SECTION II

MODIFICATIONS TO THE LNG EXPORT PROJECT DESIGN

Figure 2. 4 Wet and Dry Gas Flares

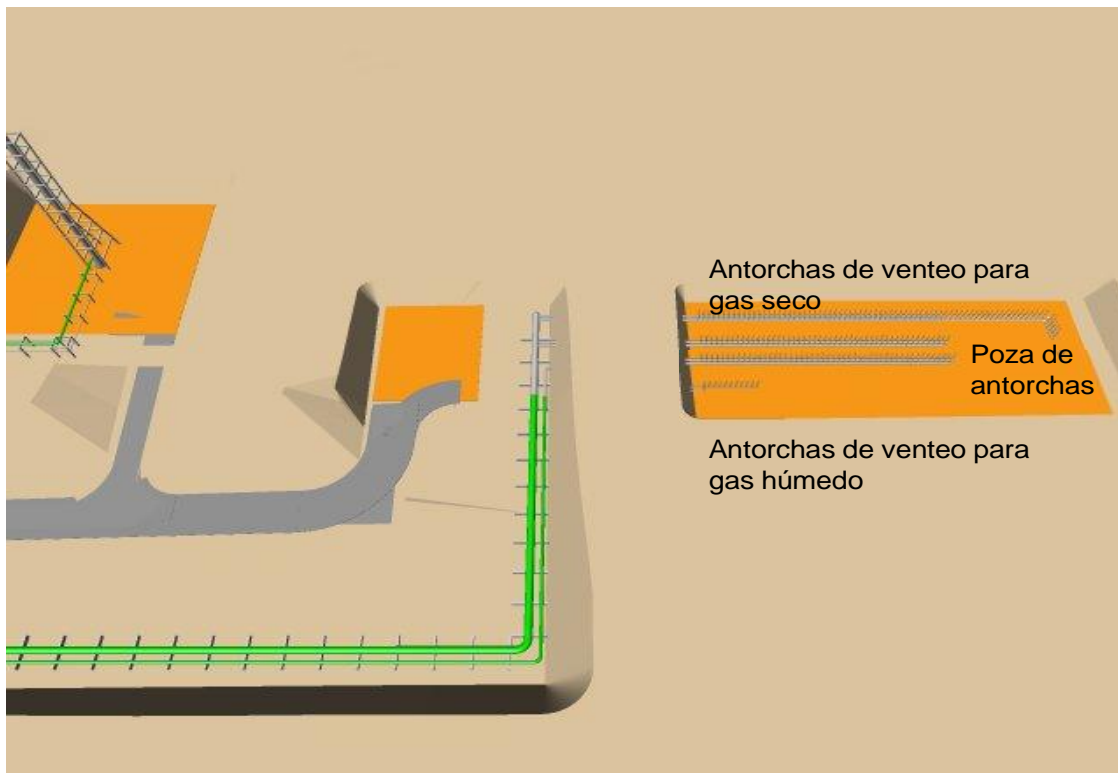
The original wet and dry gas flare system designed for the plant consisted of a two-stage vertical ground flare. The new design now has a horizontal system parallel to the ground surface and contained in a flare pit, producing less emission and lower thermal radiation. The previous design consisted of two wet and dry gas flares installed on a common tower (see Chapter II, Section 2.3.8 of the EIA). The current design proposes the installation of a series of small flare tips in a pit to reduce the effect of thermal radiation (see **Figure 2.4**). At the same time, the combustion using small flare tips is more efficient than using a single large flare, generating less atmospheric emissions.

Figure 2.7 Diesel and Gasoline Storage

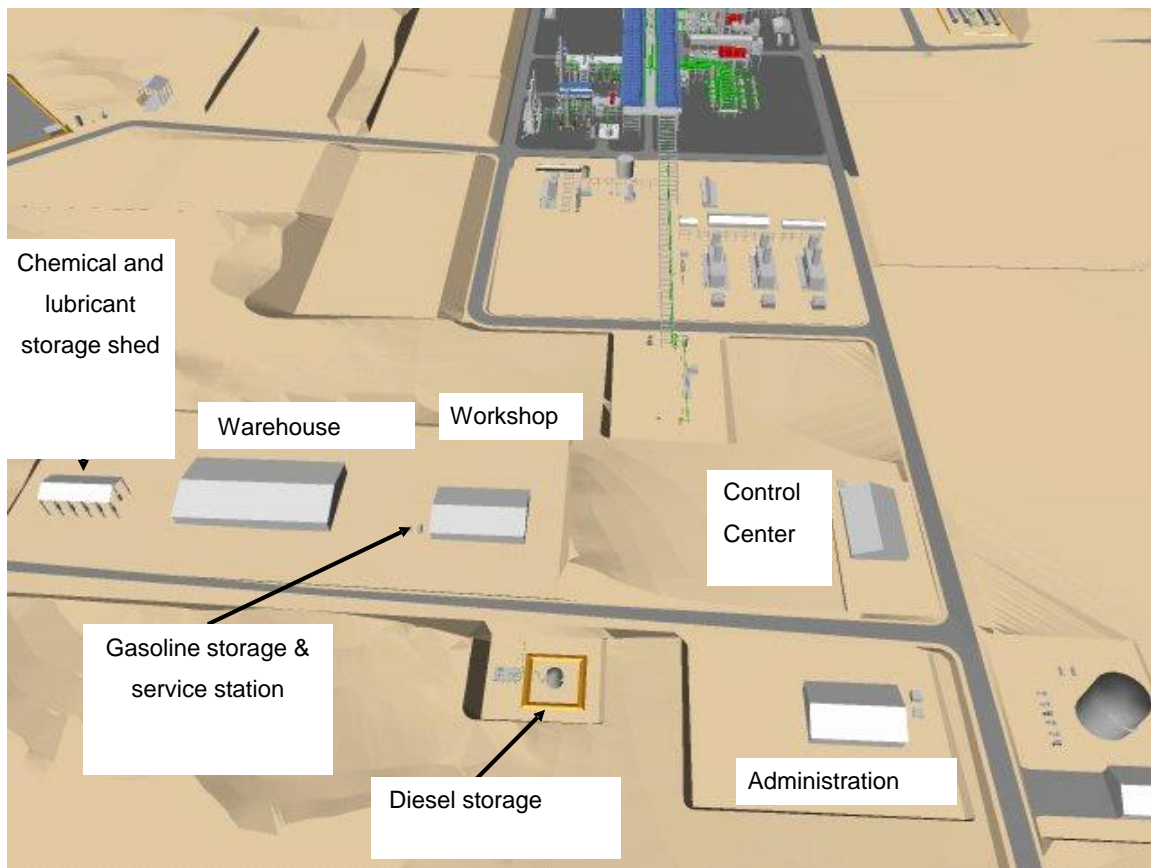
The diesel fueling area was moved from the plant area (see Section 2.3.4 Chapter II) to the administration building for safety reasons (see **Figure 2.7**). This new location will allow safer diesel fueling operations to tank trucks located outside the plant area. The size of the diesel storage tank has not been changed.

The vehicle and plant services station will be located near the Maintenance Shop. PLNG will provide a gasoline and diesel reception, storage and fueling service for motor vehicles.

Figure 2.8 Division of the Electric Substation

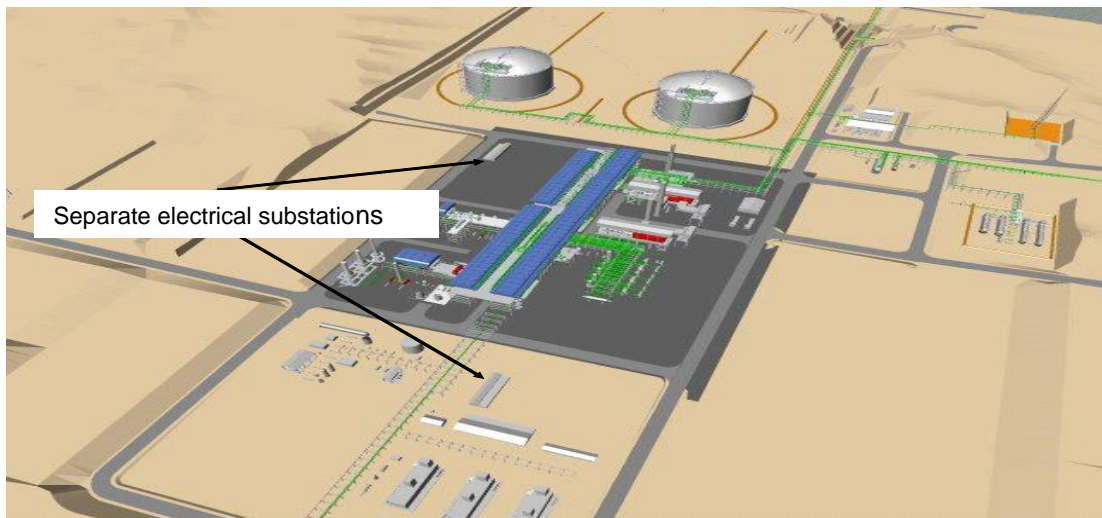
The Plant electrical substation was divided in two to reduce the electric wiring requirements and to use underground wiring for greater protection and safety (see **Figure 2.8**). Both substations are located far away from the equipment containing hydrocarbons.

Figure 2.9 Access Road to the Beach

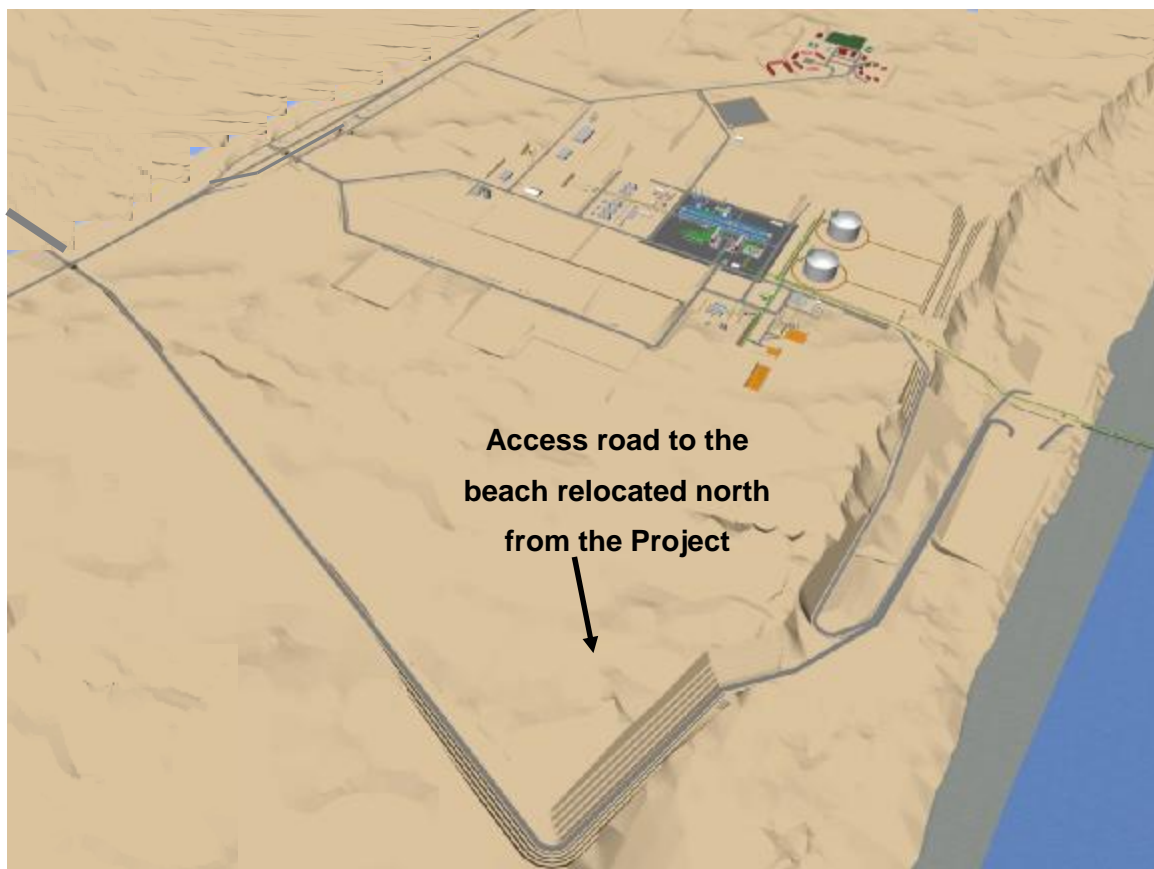
The access road to the beach was relocated along the northern property boundary and descends along the cliff to provide access to the work areas during plant construction and operations. (See **Figure 2.9**)

Figure 2. 11 ***Plant Plot Plan and Cross Section View of the Underpasses***

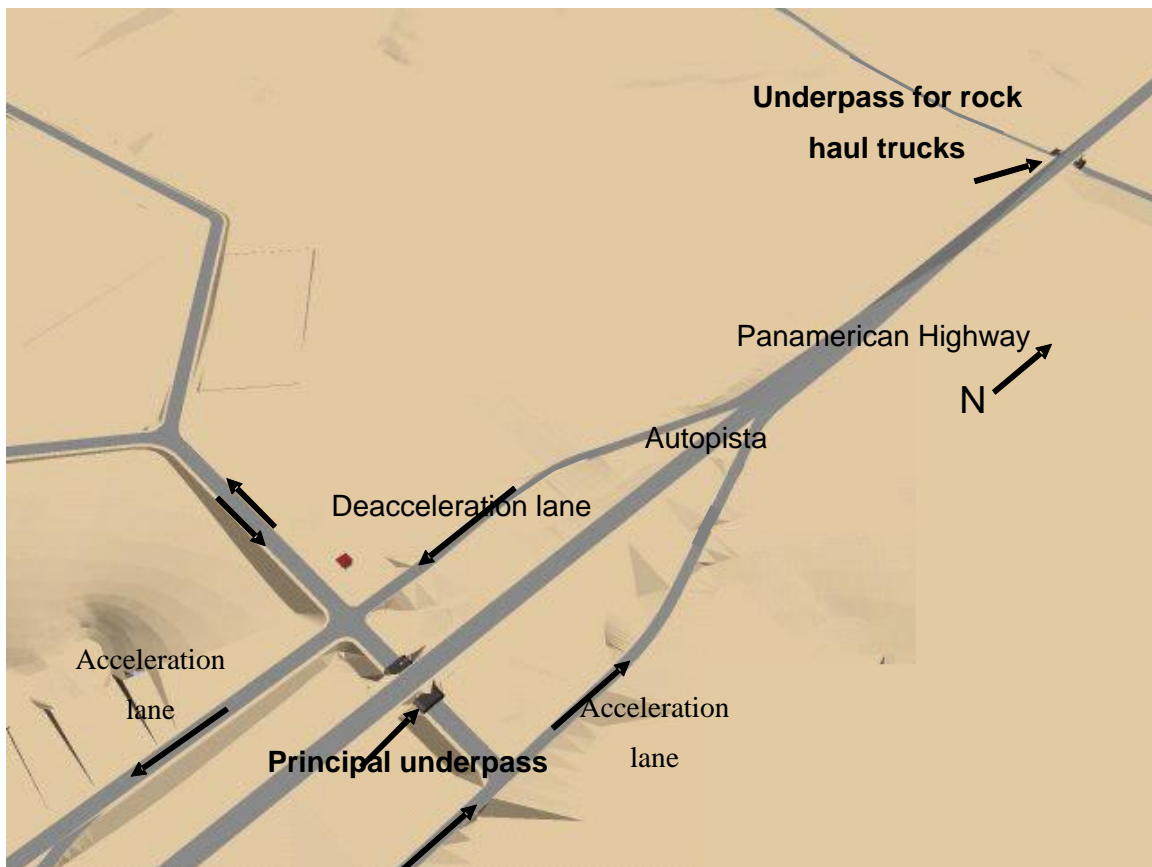
The proposed Plant access road includes the construction of two underpasses with parallel acceleration and deceleration lanes (see **Figures 2.10** and **2.11**). The underpasses will be used for: 1) allowing the entrance of vehicles from the Panamerican South Highway to the PLNG facilities, and 2) to facilitate the crossing of trucks hauling rock to be used during the plant's construction. The original access to the plant was through a direct detour road from the Panamerican highway. The use of underpasses will allow safe crossing without stopping traffic flow or reducing visibility.

Figure 2.12 Location of the Rock Load-out Jetty

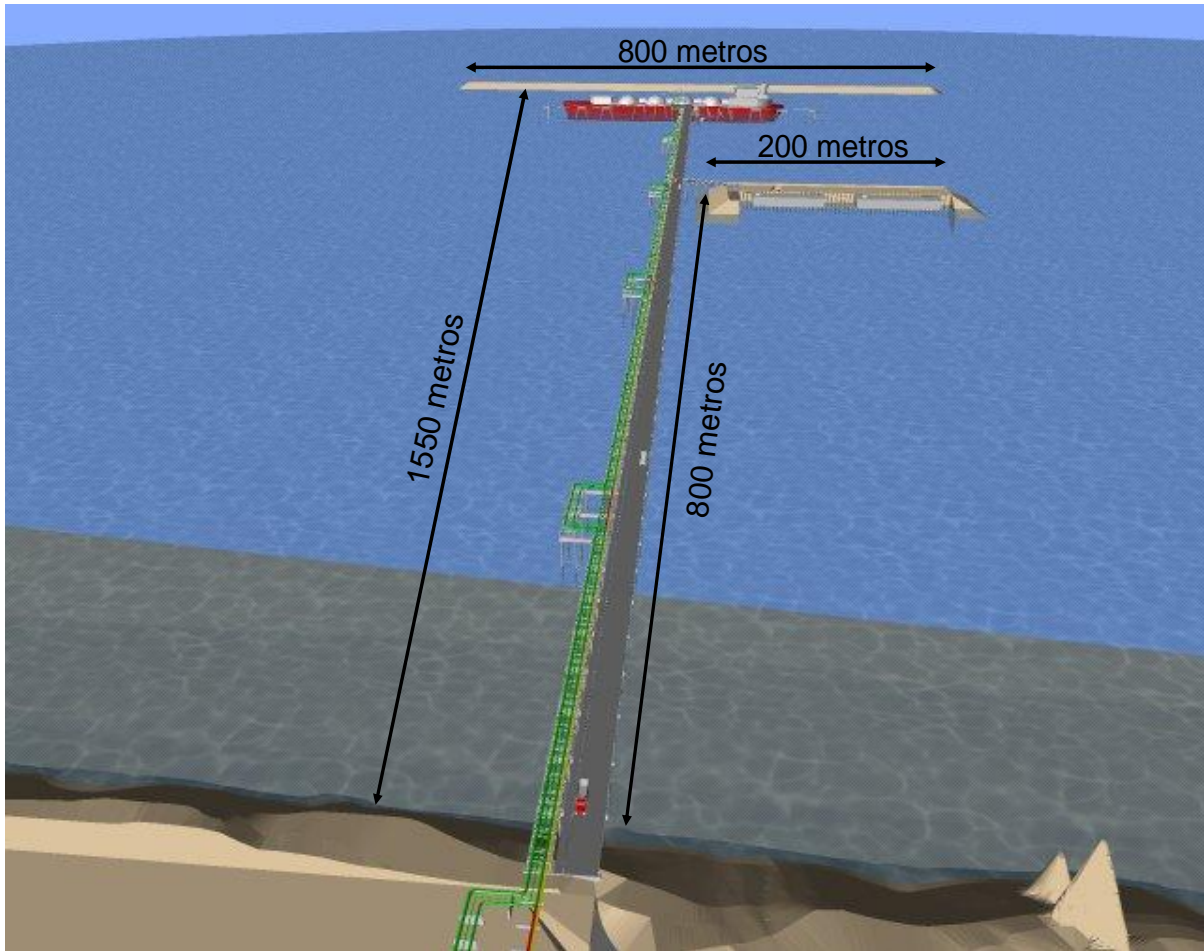
The rock load-out jetty will be 200 meters long and 8.00 meters above sea level (See **Figure 2.12**), and will be placed along the 10m depth contour of the seafloor with a similar structure to that of the breakwater.
